Re: Addendum Tolt Bridge (#1834A) Replacement (CIP 200394) Biological Assessment/  
NOAA Fisheries Reference No. 2003-01051/USFWS Reference No. 1-3-03-I-1911

This letter serves as an Addendum to the Biological Assessment (BA) for the Tolt Bridge (#1834A) Replacement (CIP 200394) project. The original Biological Assessment was prepared in July of 2003 and was submitted to National Oceanic and Atmospheric Administration Fisheries (NOAA Fisheries) and United States Fish and Wildlife Service (USFWS). NOAA Fisheries and USFWS issued their Endangered Species Act (ESA) concurrence for the BA on September 17, 2003 and February 13, 2004, respectively. Since that time, changes to the project design have occurred. These design changes have the potential to alter the location and magnitude of impacts on listed species from the proposed project. As required by ESA in cases where project elements have been altered since completion of informal consultation, the King County Department of Transportation Road Services Division (RSD) is reinitiating consultation with the Services on the proposed project by providing this Addendum. This document is intended to supplement and append the original BA an

**Revised Figure 3  
 Existing Wetlands and Streams  
 Tolt Bridge Replacement  
 King County, Washington**

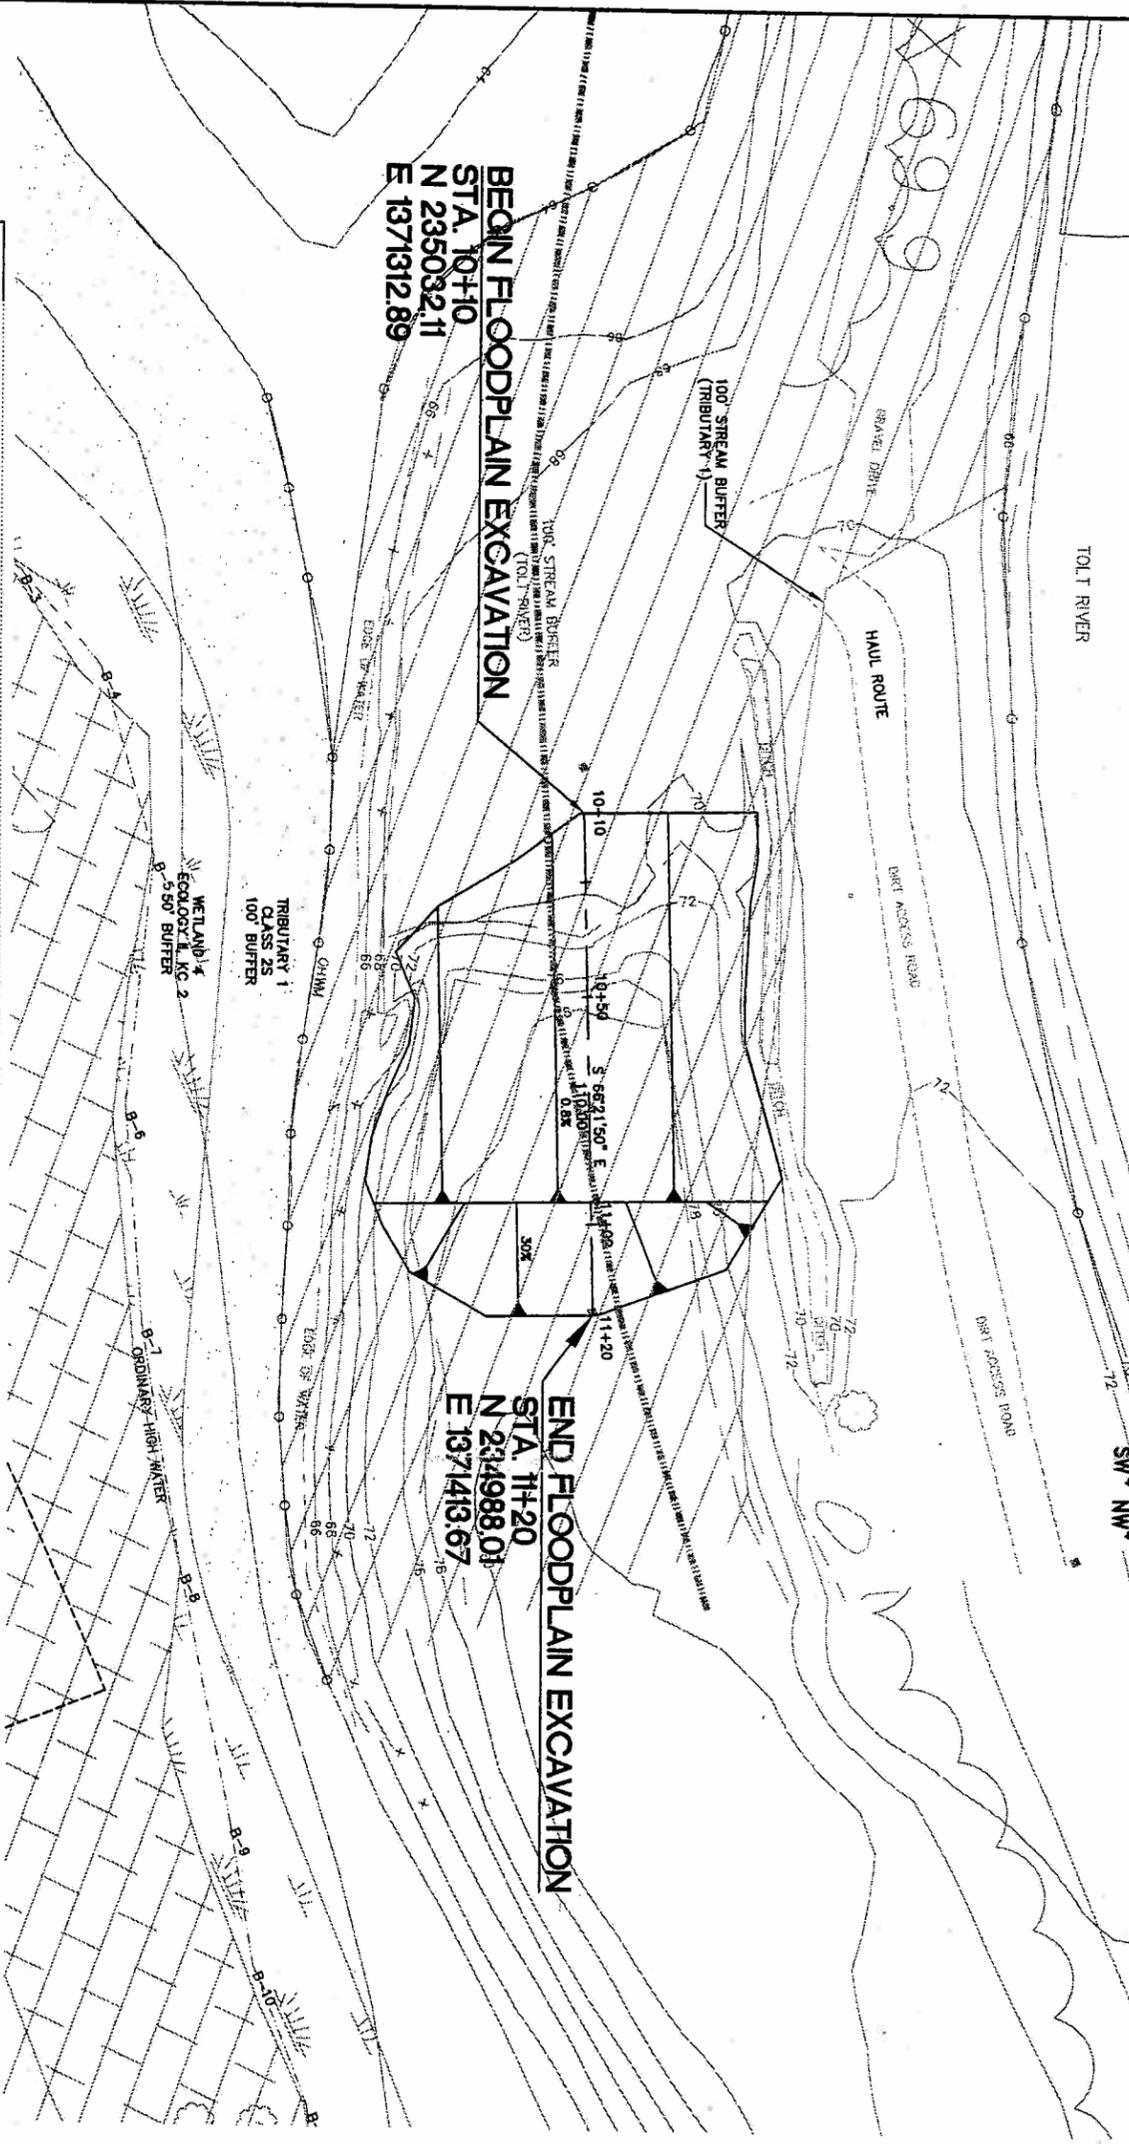
The original BA rated wetlands on the 1993 Ecology Rating System. This information has been subsequently updated and project area wetlands have been re-rated according to the 2004 Ecology guidelines (Hruby 2004) (Revised Table 2; Revised Figure 3). In addition, further field investigations indicated that Wetland 4 should be considered a Class 1 wetland based on the King County (2001) ratings system. This increase in rating class (Wetland 4 was previously reported as a King County Class 2 wetland) is due to the quality of the habitat present in the wetland, its connection to a riparian corridor, and its support of off channel habitat for fish during high flows. King County requires a 100-foot buffer on Class 1 wetlands.

SHEET 27 OF 110 SHEETS

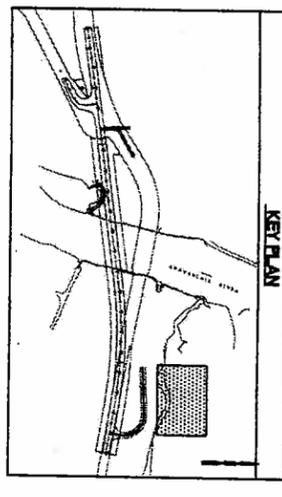
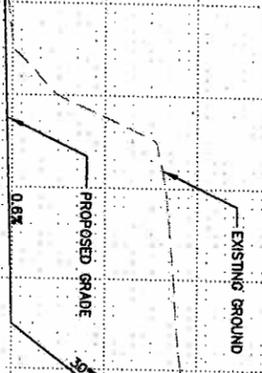
In addition to the above changes, RSD has designed a mitigation site to provide additional storage to compensate for fill placed within the floodplain of the Snoqualmie River associated with the new bridge. The mitigation site is located east of the Snoqualmie River, between NE Tolt Hill Road and the Tolt River, just south of the Tolt River dyke access. The mitigation site is located within the buffer of Tributary 1. The

The floodplain storage excavation site will be accessed from an existing maintenance road located along the south bank of the Tolt River. An excavator will be used to remove the existing soil and loaded into trucks. All excavated material will be hauled offsite and disposed of in an approved facility and no stockpiled material will be left onsite. Subsequent to excavation, the floodplain mitigation site will be re-vegetated with appropriate native trees and shrubs.
